# STRUCTURAL PEER REVIEW

14-16 Victoria St Kogarah

Prepared for  
Georges River Council

21 August 2019

Overall Photo of 14-16  
Victoria Street

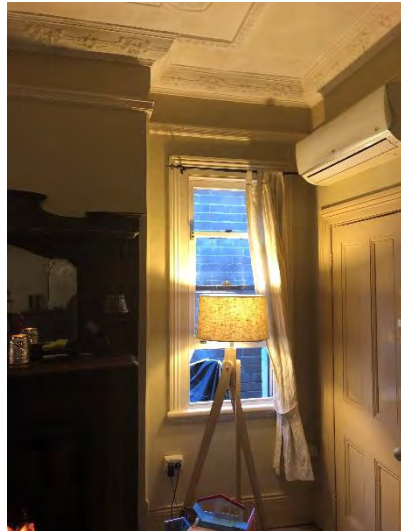
Sagging in U14 balcony

14 Victoria Street- Internal  
Room Ceiling

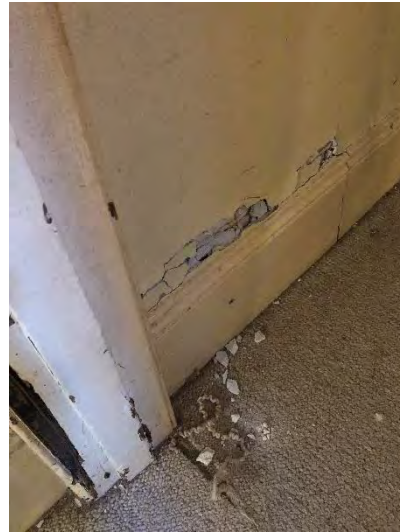
Cracks in Ceiling

14 Victoria Street- Corridor

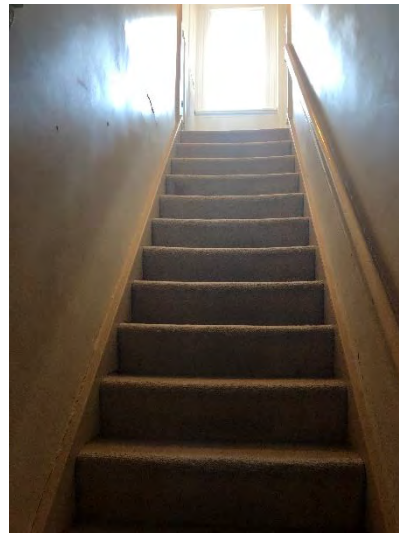
Crack on the load bearing wall

14 Victoria Street- Stair

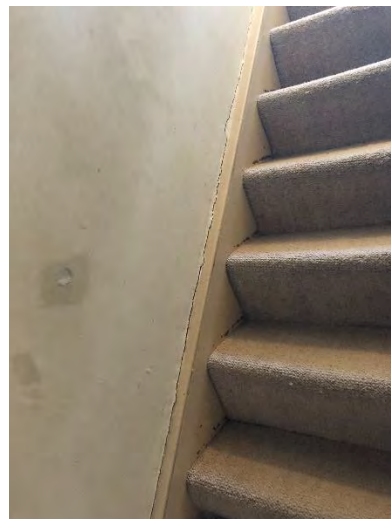
General Shot

BASEMENT FLOOR PLAN  
(LEVEL B1)

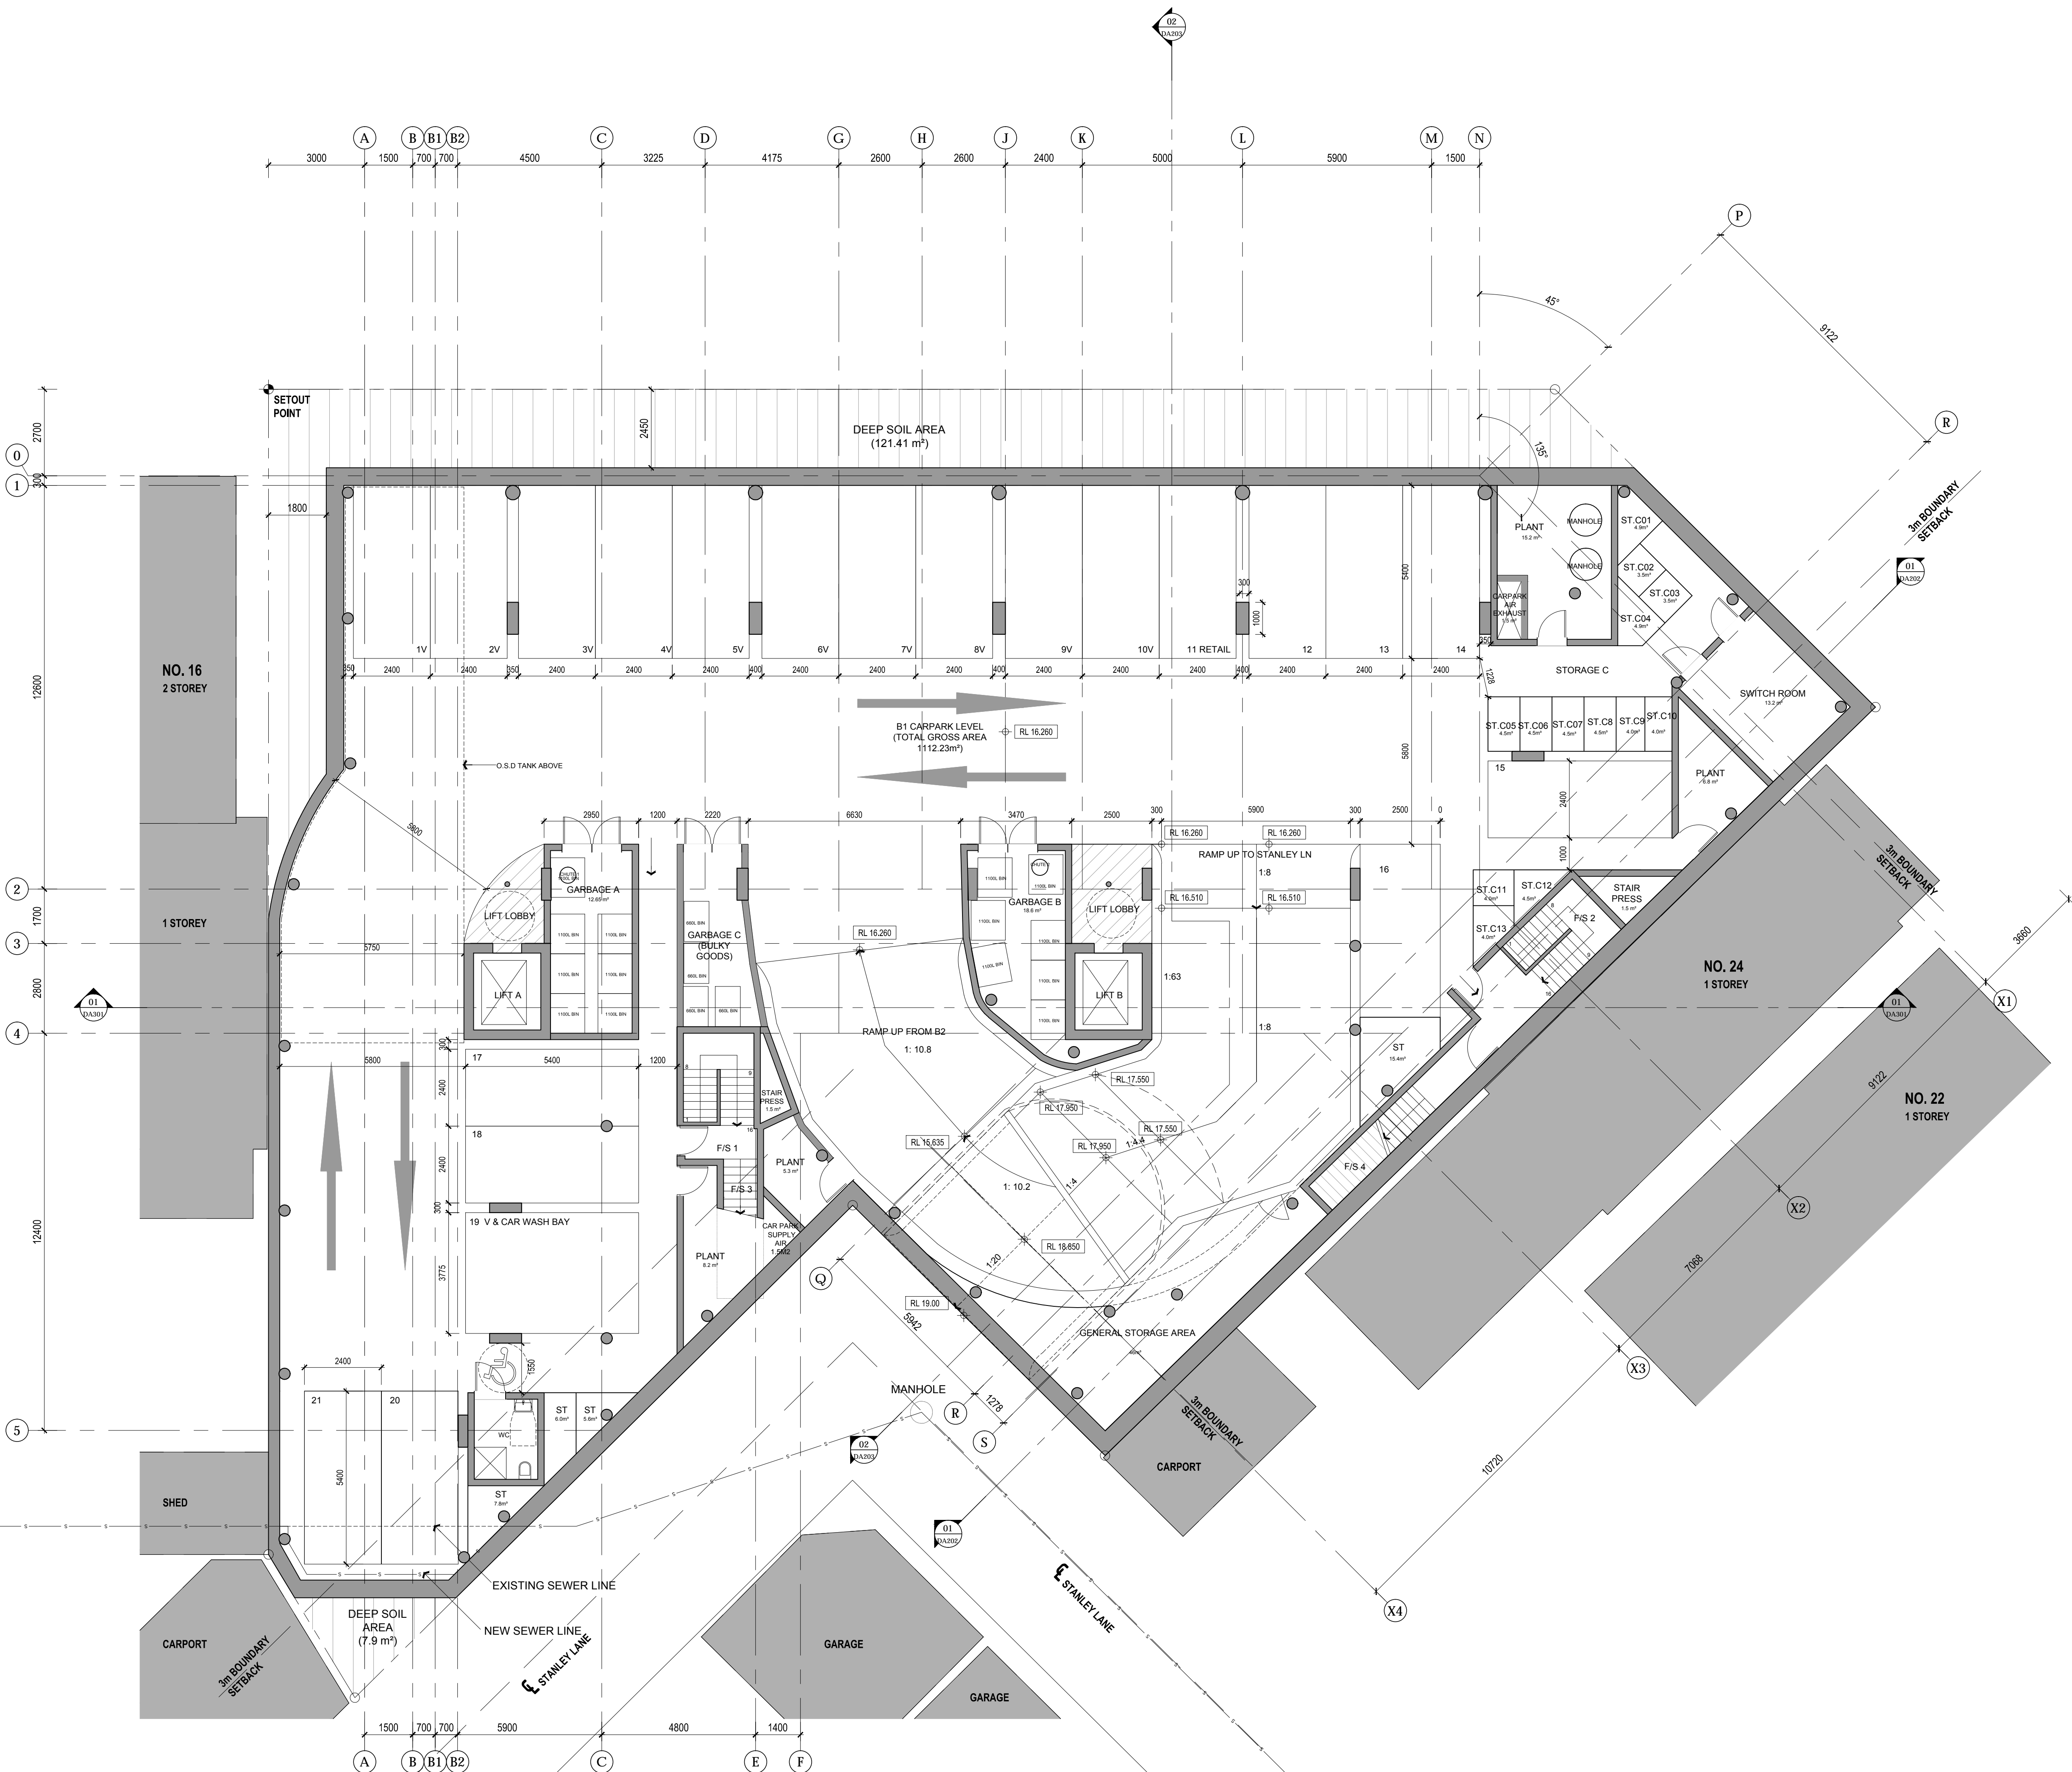
Cardno reviewed the proposed development plans at 18-24A Victoria Street regarding to the potential impacts of basements excavation on the 14-16 Victoria Street. The plans are architectural only.

- We agree that 9m deep excavation has the potential of causing lateral movement of the load bearing walls of 14-16 Victoria Street. However, we believe that with a proper designed shoring wall system, the lateral movement could be limited to be in a range tolerated by the masonry walls

- Bulk excavation on the proposed development has the potential to cause lateral displacement in the sandstone underneath of 14-16 Victoria Street due to sandstone stress relief. The magnitude of the displacement and potential for damage can be determined by a geotechnical and structural engineer, and if a potential for damage exists, the shoring wall can be designed to avoid or minimise the movement.
